RE: 1 CRESCENT STREET, HOLROYD PLANNING PROPOSAL (PP_2019_CUMB_002_0)

1 CRESCENT STREET, HOLROYD PLANNING PROPOSAL (PP_2019_CUMB_002_0)

RE: Gateway Determination – PP_2019_CUMB_002_00

Figure 1: Extract of 17 August 2021 TfNSW Correspondence, named 'High Level Sketch of Pedestrian Bridge on Woodville Road'.

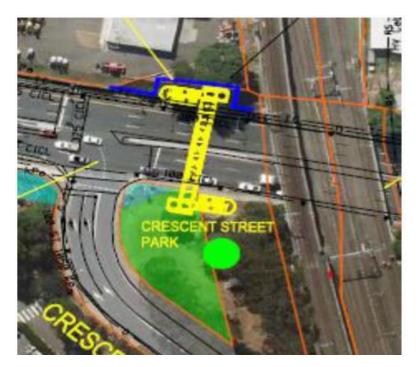
Given the land required for the bridge is under private ownership and unable to be acquired, it is not reasonable to undertake any detailed design work or acquire costings of a proposed pedestrian bridge that could not be delivered. Extracts of an indicative land acquisition is provided below in Figures 1 and 2, which has been informed on advice from Urbis' Transport team.

Figure 2: Estimated land required to be acquired to allow for bridge landing and an accessible compliant pedestrian bridge, amounting to an estimate of 300sqm of land.
